## ENVIRONMENTAL REVIEW COMMITTEE REPORT

**Project Name:** Highlands Reservoir & Emergency Generator

**Project Number:** LUA15-000864, ECF, CU-H, SA-H, MOD

**PROPOSED DRAINAGE PLAN**

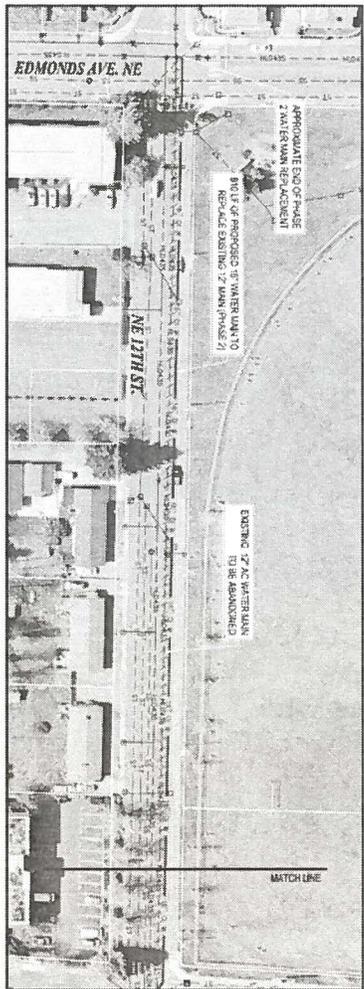
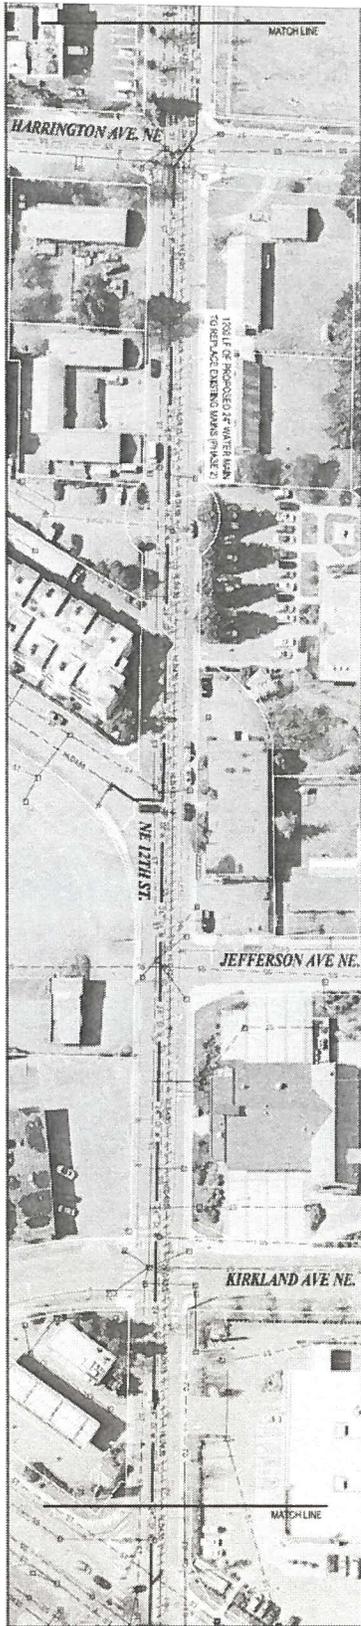
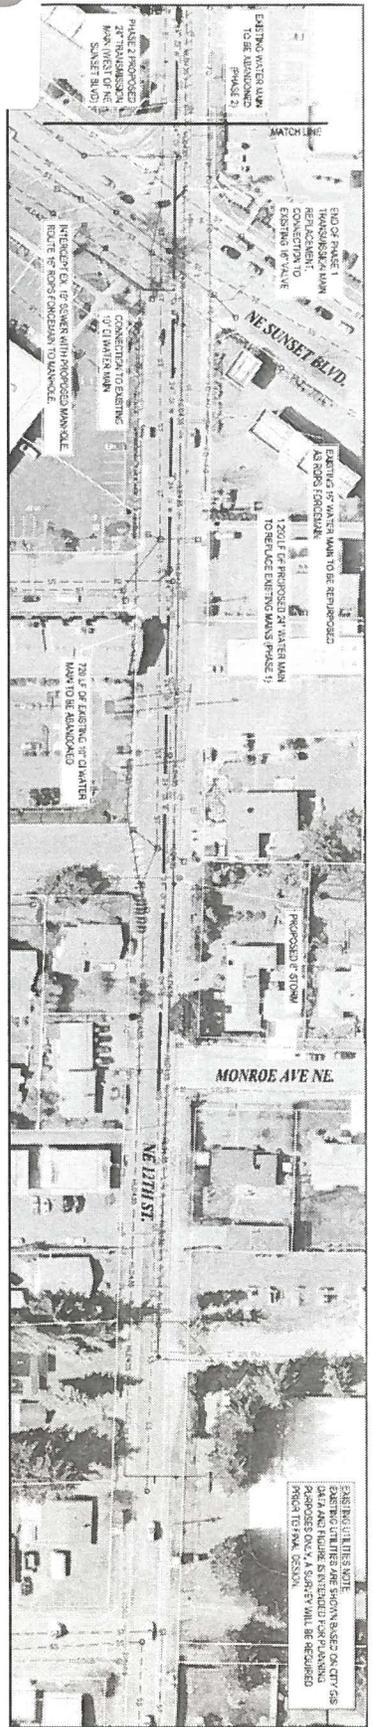
4. A study shall be required and included in the TIR to verify downstream capacity for the overflow from the reservoirs and prove the flows will have no environmental impacts.
5. Surface water system development fee (SDC) will be applicable. The current rate of SDC fee \$0.594 per square foot of new impervious surface area, but not less than \$1,350.00.
6. A Construction Stormwater General Permit from Department of Ecology will be required if grading and clearing of the site exceeds one acre. A Stormwater Pollution Prevention Plan (SWPPP) is required for this site.
